## **Minutes of the meeting of the Planning Committee held at Banwell Youth & Community Centre, 7 pm on Monday 12<sup>th</sup> of May 2025.**

# PLANNING COMMITTEE REFORM – SUMMARY & KEY CONCERNS

25/P/1113/FUL Land to North of Station Road, and West of Nye Road, Sandford.

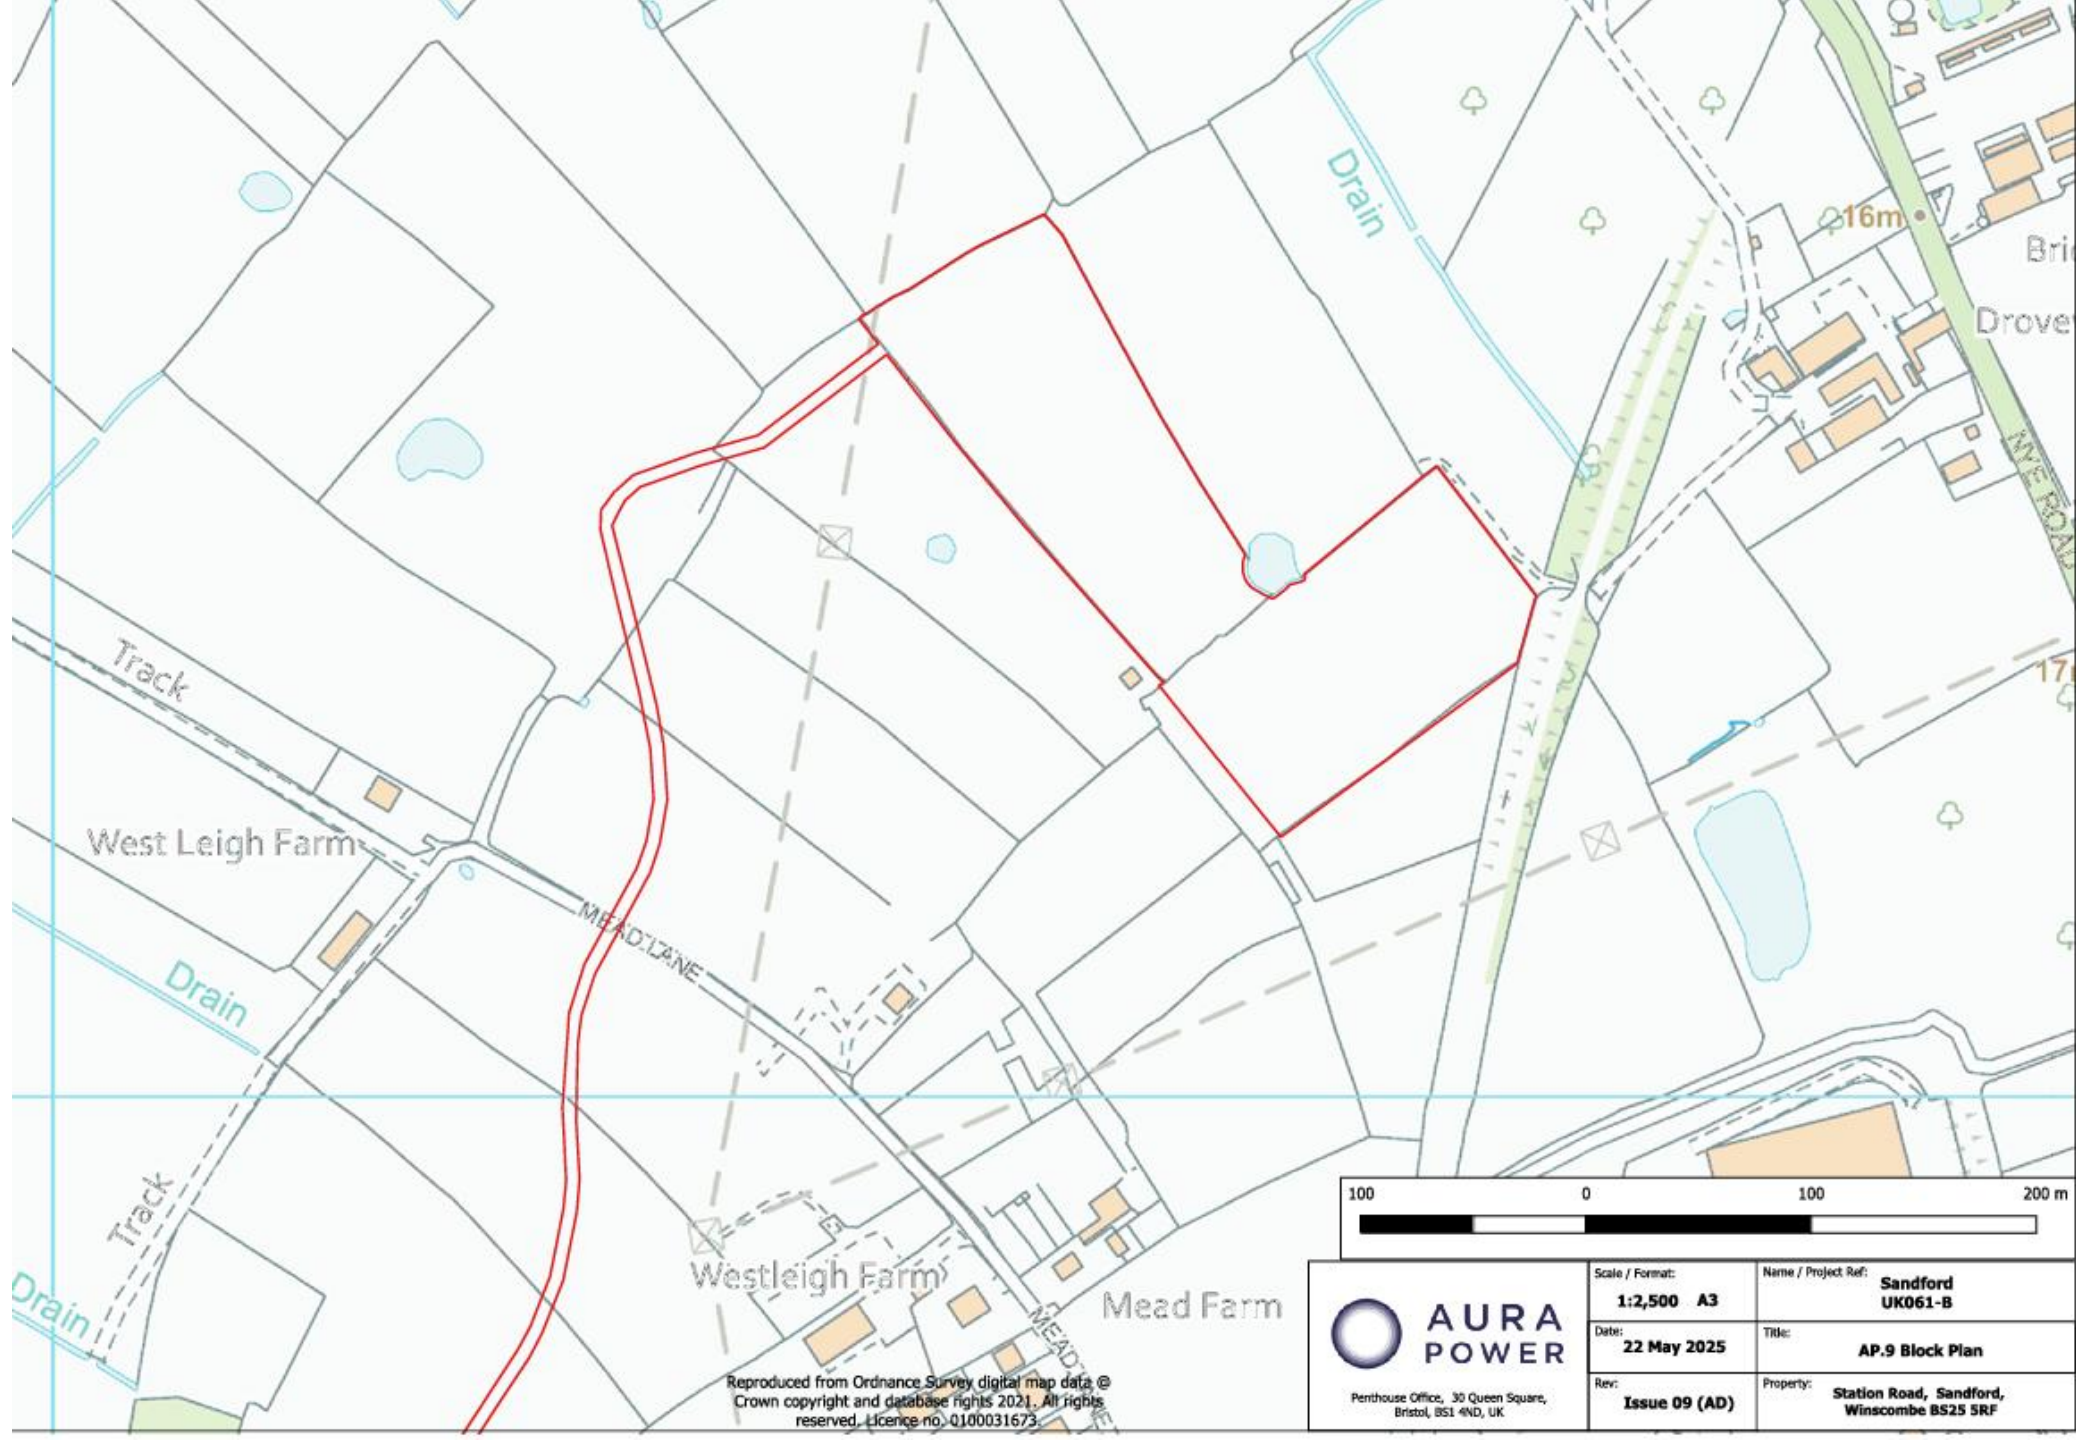
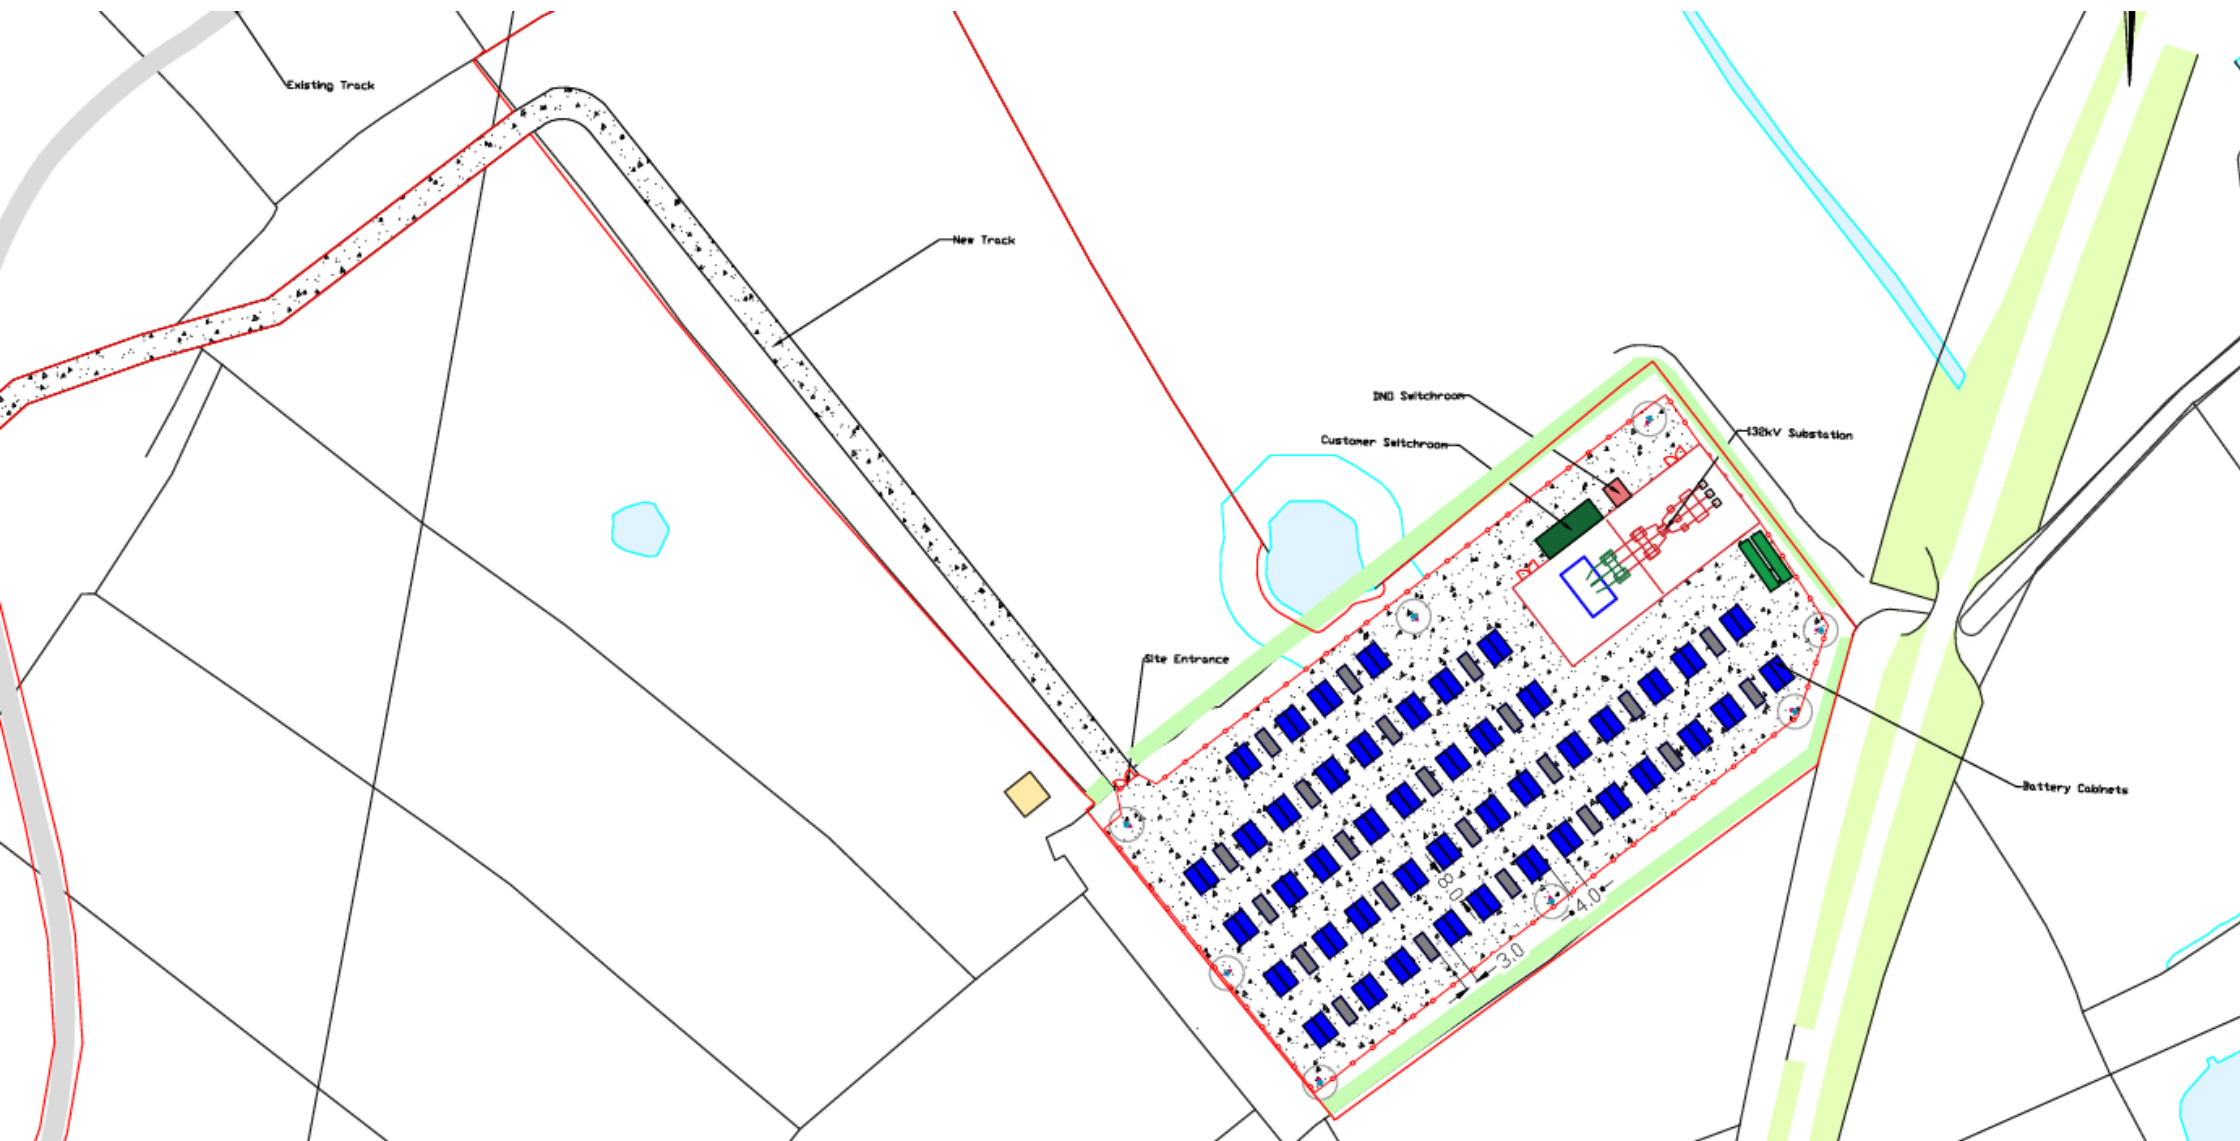
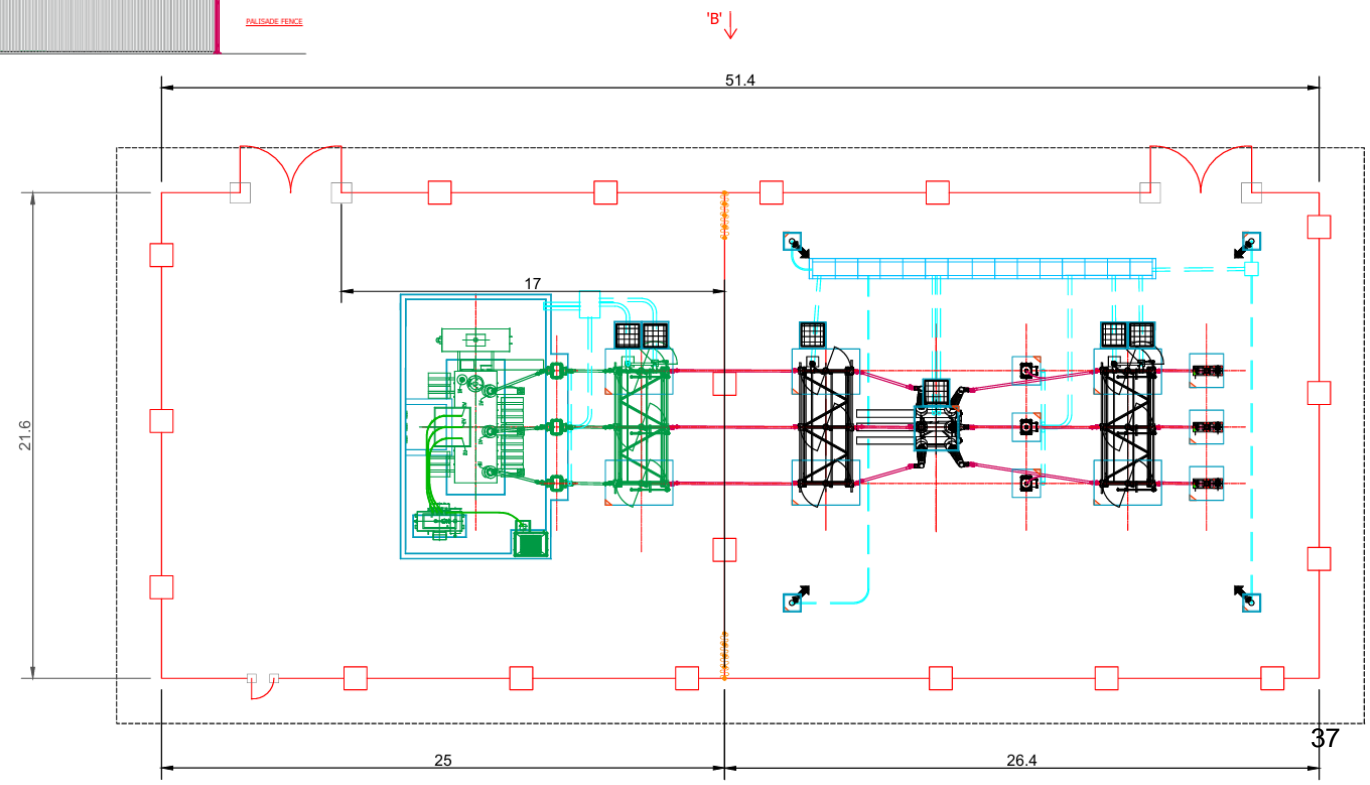
Topic	Environment and biodiversity comments	Recommendation
<b>Biodiversity Net Gain</b>	The applicant's intention is to deliver 6.59 BNG credits offsite. Onsite delivery must be considered the first and preferred option in line with the BNG statutory framework . Offsite provision should only be accepted where onsite options have been fully explored and shown to be ecologically or practically unviable.	The applicant should be required to provide a clear and robust justification for why onsite. If no such justification is provided; appropriate measures should be secured to deliver the additional 6.59 BNG credits onsite.
<b>Lighting</b>	The site lies within Zone C of the North Somerset and Mendip Bats Special Area of Conservation (SAC). While activity of Annex II bat species was recorded as low, this does not remove the requirement to prevent disturbance to potential commuting and foraging routes, especially given the site’s touches the Strawberry Line, which functions as a key wildlife corridor.	External lighting should be avoided wherever possible. Where lighting is necessary, the applicant should be required to submit a lux contour plan to demonstrate that light spill remains below 0.5 lux along any hedgerows or tree lines, in line with SAC guidance.

# **25/P/1098/FUL Land South Of Dolemoor Lane Congresbury**

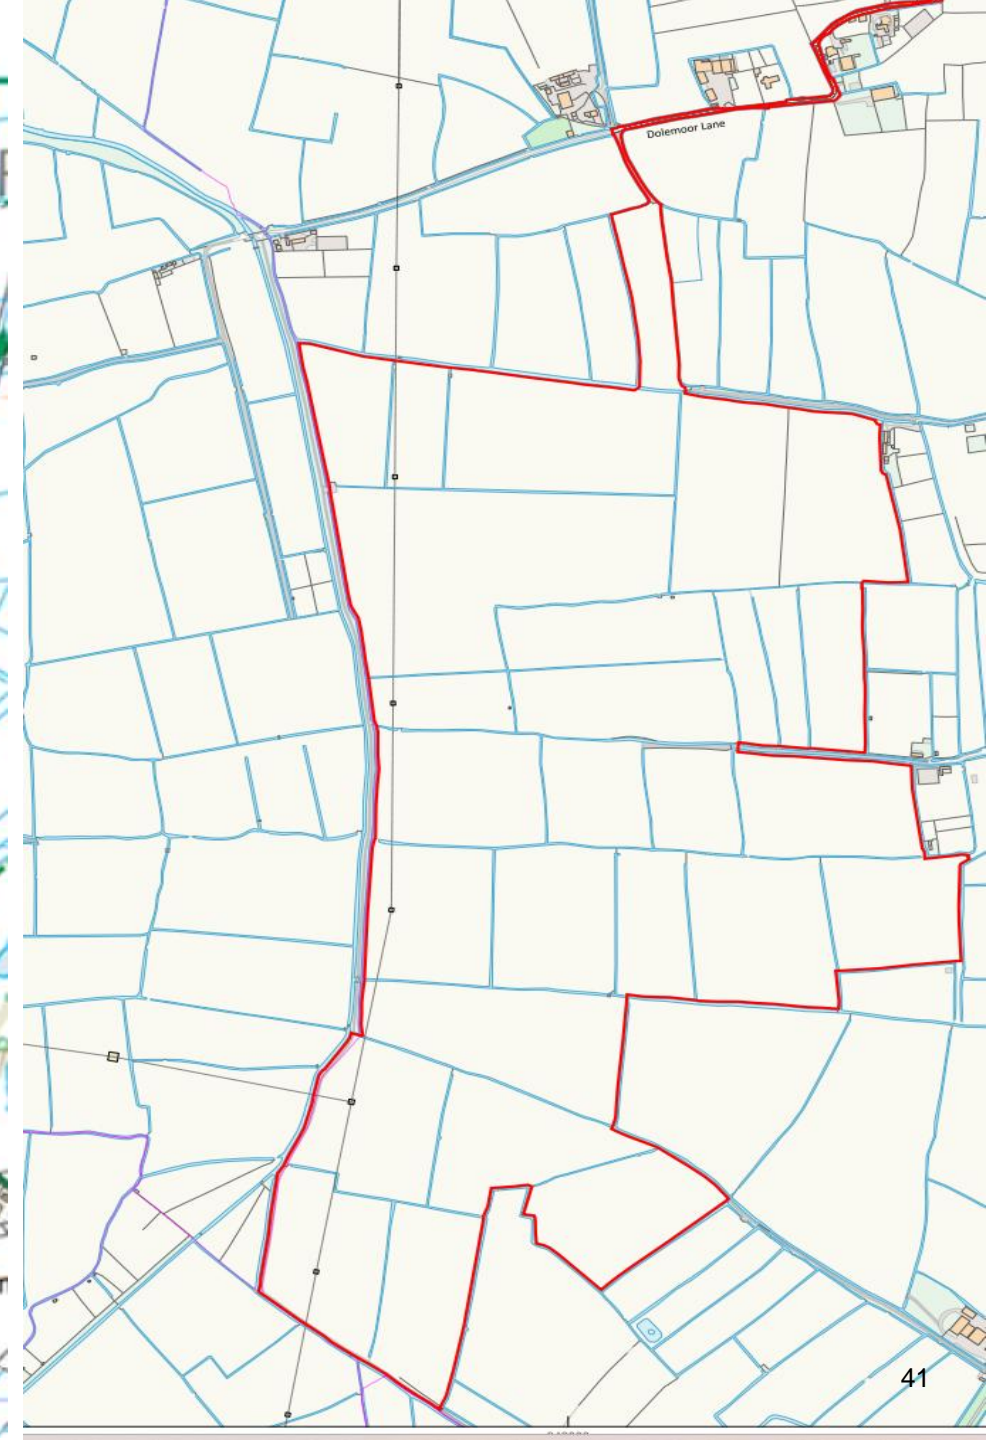
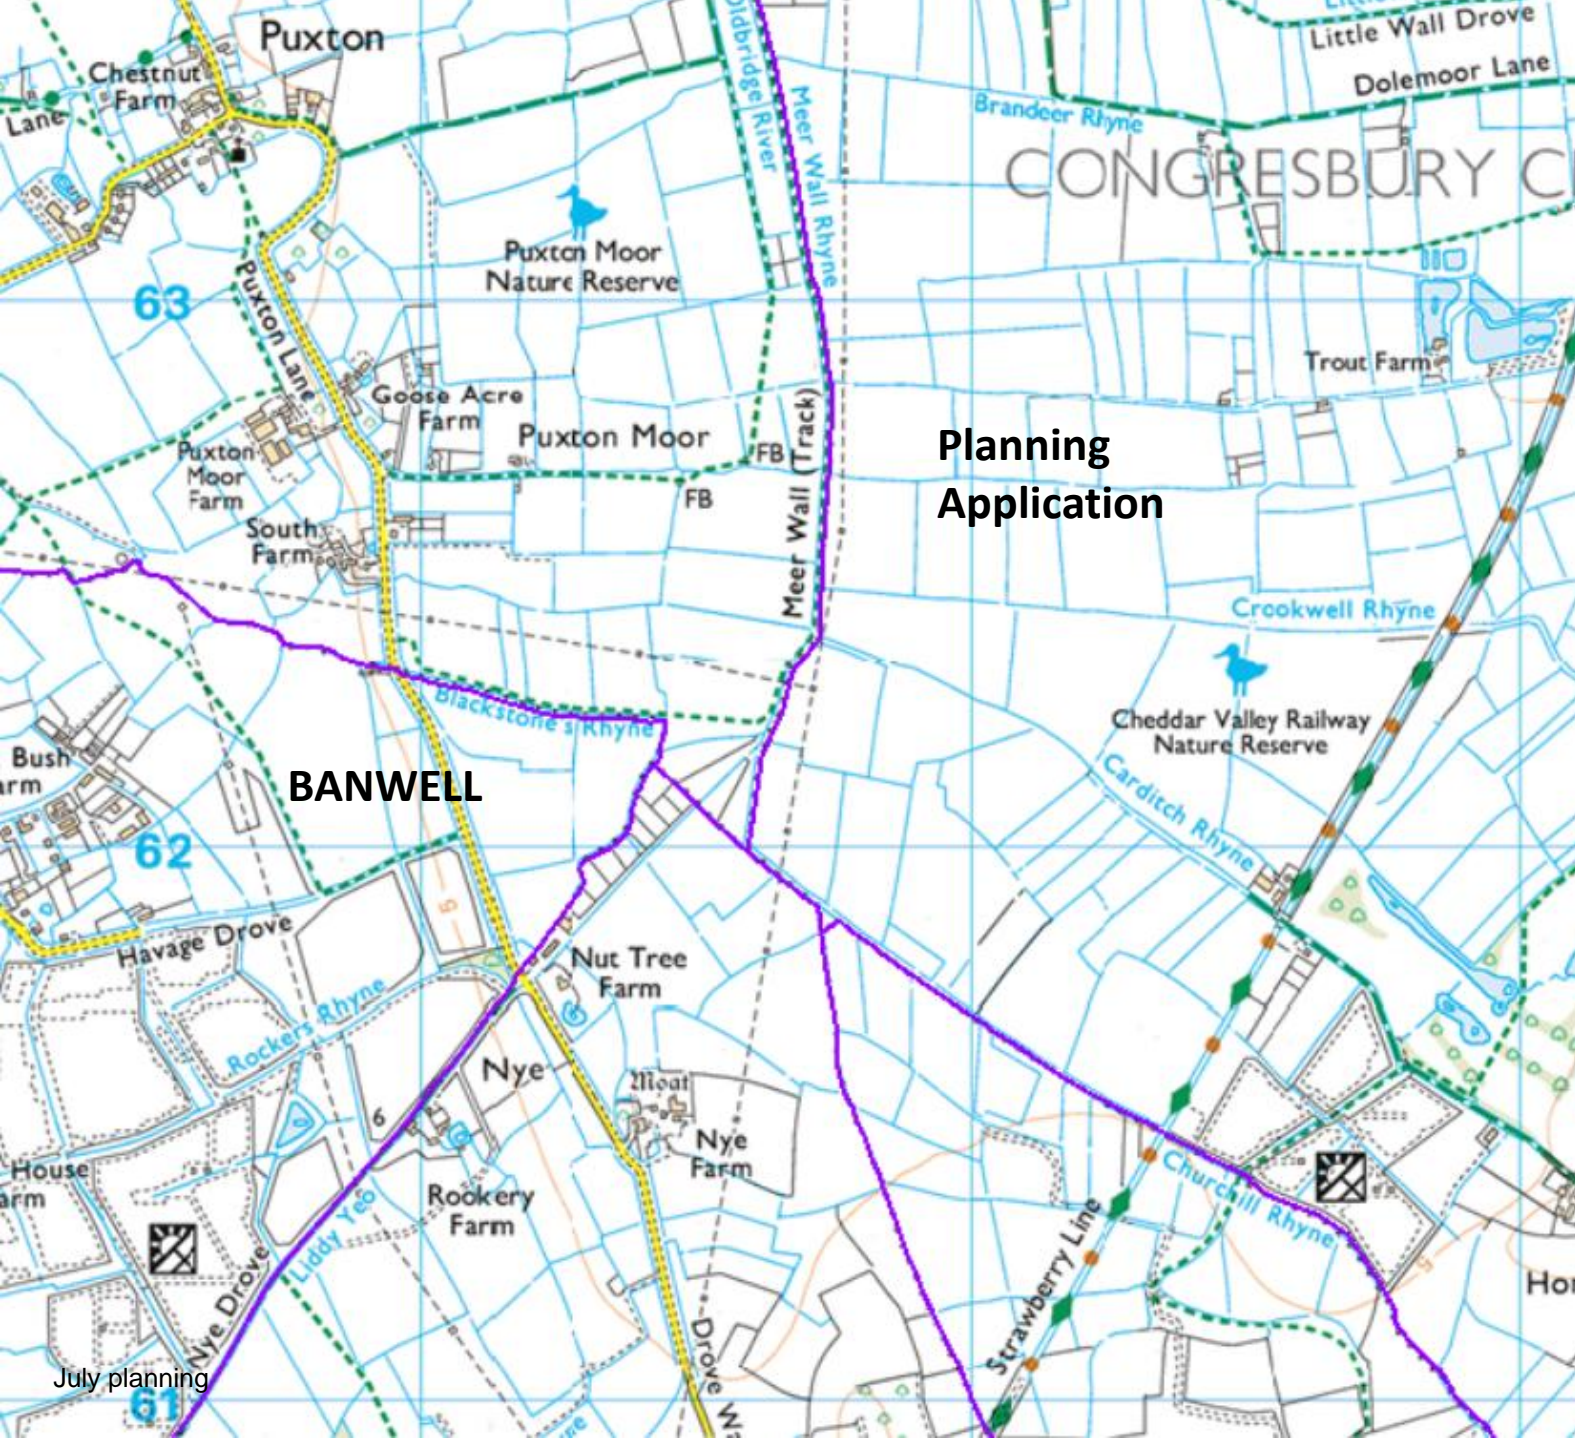
Topic	Environment and biodiversity comments	Recommendation
<b>Biodiversity Net Gain</b>	The applicant's intention is to deliver 6.59 BNG credits offsite. Onsite delivery must be considered the first and preferred option in line with the BNG statutory framework . Offsite provision should only be accepted where onsite options have been fully explored and shown to be ecologically or practically unviable.	The applicant should be required to provide a clear and robust justification for why off site delivery. If no such justification is provided; appropriate measures should be secured to deliver the additional 6.59 BNG credits onsite.
<b>Lighting</b>	The site lies within Zone C of the North Somerset and Mendip Bats Special Area of Conservation (SAC). While activity of Annex II bat species was recorded as low, this does not remove the requirement to prevent disturbance to potential commuting and foraging routes, especially given the site’s touches the Strawberry Line, which functions as a key wildlife corridor.	External lighting should be avoided wherever possible. Where lighting is necessary, the applicant should be required to submit a lux contour plan to demonstrate that light spill remains below 0.5 lux along any hedgerows or tree lines, in line with SAC guidance.
